NUCLEAR STATION PROCEDURE ROUTING

FORM 09-02B  
PROCEDURE HISTORY

Procedure Number: DSSP/0010-01\*

DETERMINING SAFE SHUTDOWN PATHS FOR EXTENSIVE PLANT DAMAGE

Figure 1

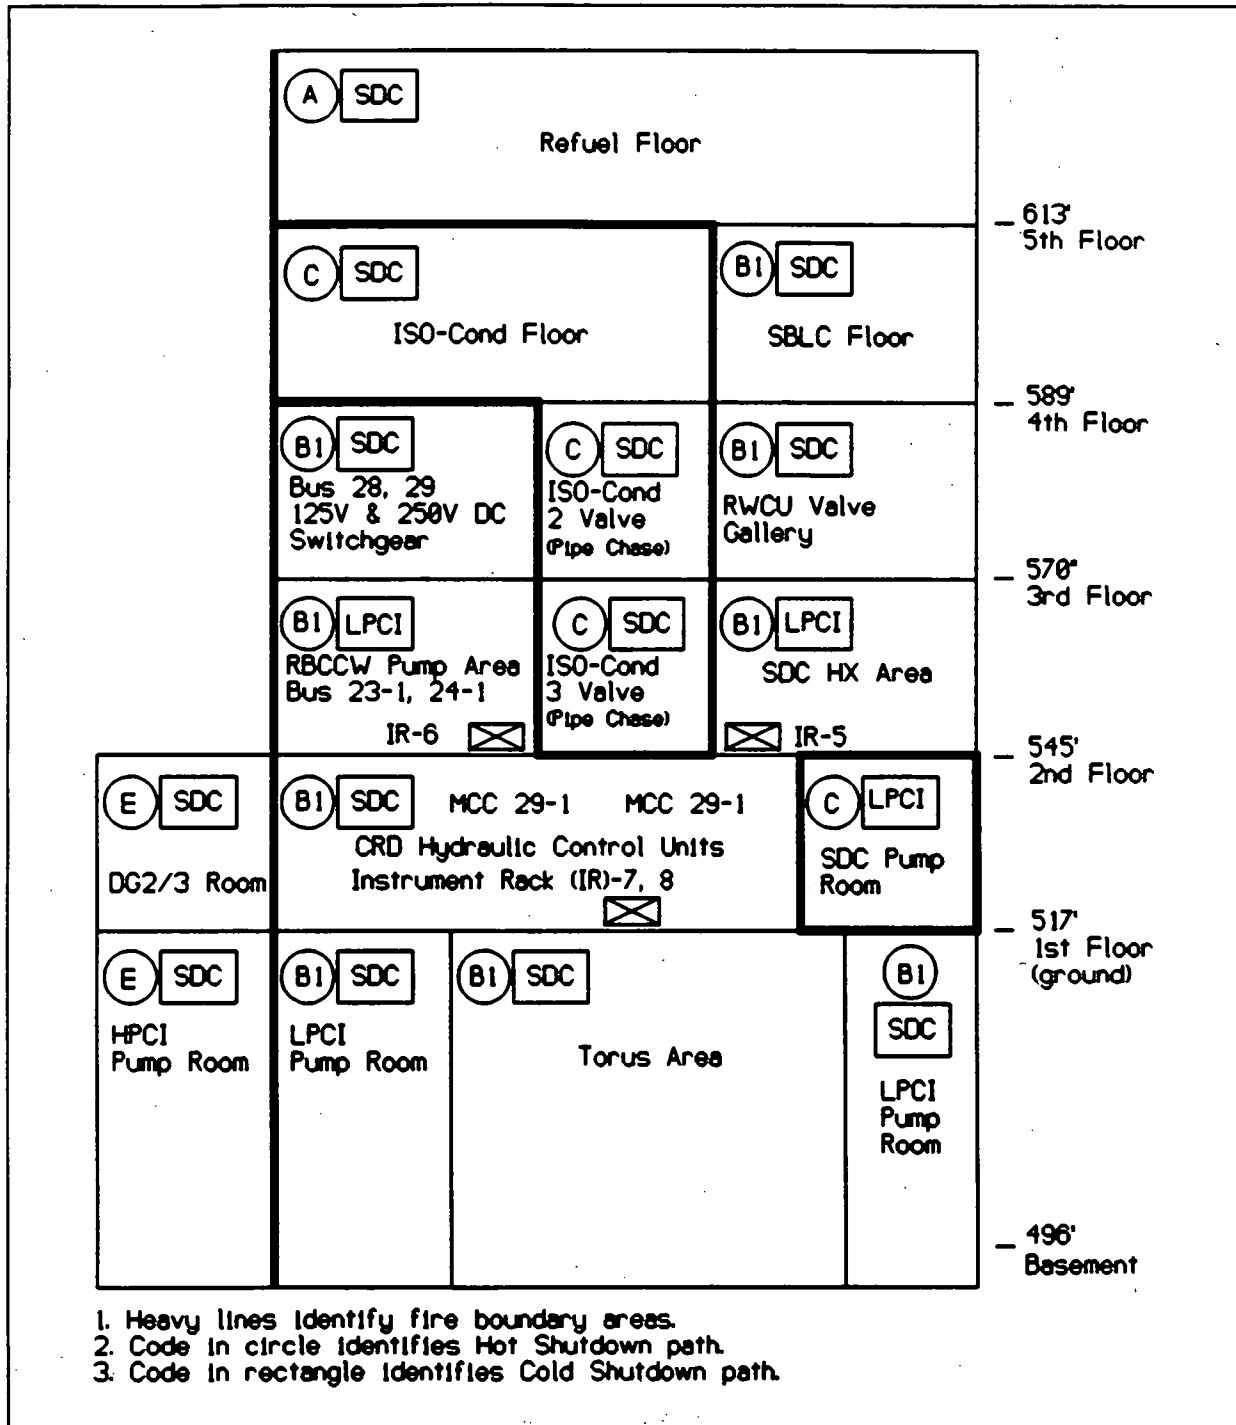
Description and JUSTIFICATION for procedure or change: Correct typos in Figure 1 and Figure (Fig 1, change MCC 29-1 to 28-1; Fig 2, Change MCC 29-1 to MCC 38-1 and 39-1). Added MCC 29-4 as this is in fire area. Changed EPIP 200-T1 to 0200-01. EPIPs were recently revised. This change reflects the new procedure numbers.
